# UNITED STATES PATENT AND TRADEMARK OFFICE

APPLICATION NO.	FILING DATE	FIRST NAMED INVENTOR	ATTORNEY DOCKET NO.	CONFIRMATION NO.
10/795,878	03/08/2004	Chi-Ming Huang	250913-1150	2105

<b>Office Action Summary</b>	<b>Application No.</b> 10/795,878	<b>Applicant(s)</b> HUANG ET AL.	
	<b>Examiner</b> Jason Uhlenhake	<b>Art Unit</b> 2853

## DETAILED ACTION

FIG. 9

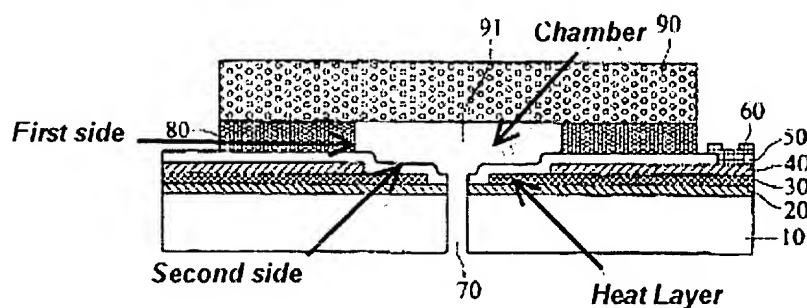
- ***regarding claim 1***, providing a substrate and a porous material (Figure 9; Column 2, Lines 12 – 31; Column 3, Lines 47 - 53)
- forming a heating layer on the substrate; forming a conductive layer on the substrate, wherein the conductive layer conducts a current to the heating layer, and a

heating area is defined by the conductive layer and the heating layer; (Column 2, Lines 14 – 31; Column 3, Lines 21 – 35)

- forming a chamber (91) for storing liquid above the heating area, wherein the chamber includes a first side and a second side, the first side faces the heating area, the second side is connected to the first side, and the chamber is formed with an exit, from which the liquid is dispensed, on the second side; (Figure 9)
- placing the porous material (90) on the chamber (91) so that the liquid flows into the chamber therethrough (Figure 9; Column 2, Lines 29 – 31)

- **regarding claim 11**, a substrate; heating layer disposed on the substrate to dispense liquid; conductive layer disposed on the substrate to conduct a current to the heating layer, wherein a heating area is defined by the conductive layer and the heating layer (Figure 9; Column 2, Lines 14 – 31; Column 3, Lines 21 – 35)
- chamber, disposed on the heating area, having a first side and a second side, wherein the first side faces the heating area, the second side is connected to the

first side, and the chamber is formed with an exit, from which the liquid is dispensed, on the second side (Figure 9)

- porous material disposed on the substrate, wherein the liquid flows into the chamber through the porous material (Figure 9; Column 2, Lines 29 – 31)

- forming an adhesive layer (80) on the conductive layer (40) (Figure 9)

- placing the porous material on the adhesive layer to form a chamber (91) for storing liquid, wherein the liquid flows into the chamber through the porous material, the chamber includes a first side and a second side, the first side faces the heating area, the second side is connected to the first side, and the chamber is formed with an exit, from which the liquid is dispensed, on the second side; (Figure 9)

- **regarding claim 18**, wherein the porous material (90) includes a groove by cutting (no structural limitation for an apparatus claim, therefore it is not given

patentable weight) to form the chamber before placing on the adhesive layer (80)

- an adhesive layer (80) on the conductive layer (40) (Figure 9)
- porous material, disposed on the substrate, including a chamber (91), wherein the liquid flows into the chamber through the porous material, the chamber includes a first side and a second side, the first side faces the heating area, the second side is connected to the first side (Figure 9)
